Region 9 Enforcement and Compliance Assurance Division
INSPECTION REPORT

Inspection Date:	December 17, 2024	Inspection Announced: Yes	
Media:	Safe Drinking Water Act		
Regulatory Program(s)	Public Water System Supervision		
Facility or Site Name:	Havasu Water Company		
Facility/Site Physical Location:	148896 Havasu Lake Road		
(city, state, zip code)	Needles, CA 92363		
Mailing Address:	P.O. Box 1690		
(city, state, zip code)	Havasu Lake, CA 29363		
County:	San Bernardino		
Facility/Site Contact:	Jennifer Hodges	President	
	havasuwat@outlook.com		
Facility/Site Identifier:	PWS I.D. 090600202		
EPA Inspectors:			
Christopher Chen (author)	Signature: CHRISTOPHER CHEN Digitally signed by CHRISTOPHER CHEN Date: 2025.02.06 09:07:00 -08'00'		
	ECAD-3-3	Inspector	(213) 244-1853
David Parker	NEIC	Inspector	(303) 462-9012
Supervisor Review:			
Lawrence Torres	Signature:		
	ECAD-3-3	Manager	(415) 947-4211

Photograph 2. The leaking diesel tank near Lake Havasu's shore was removed but contaminated soil remained.

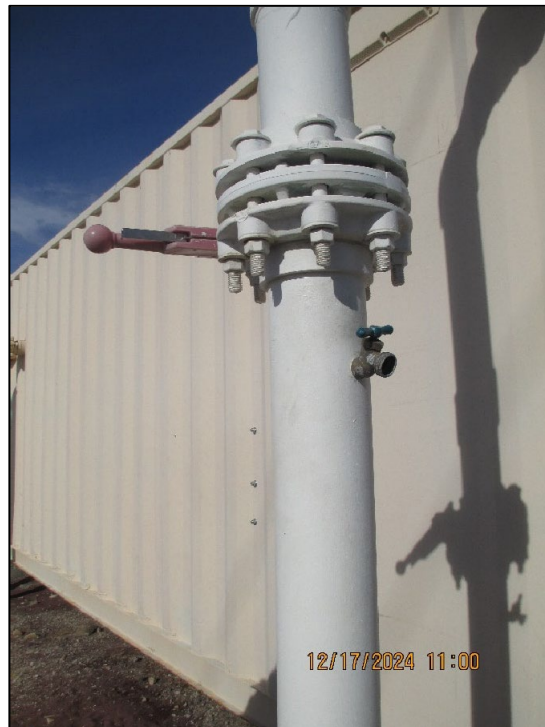
8. While the intake location's diesel tank was removed, contaminated soil remained near Lake Havasu's shore.
9. The storage tank's second overflow screen at the inlet line was higher than the recommended 12-24 inches above the surface and did not have drainage away from the foundation of the storage tank.
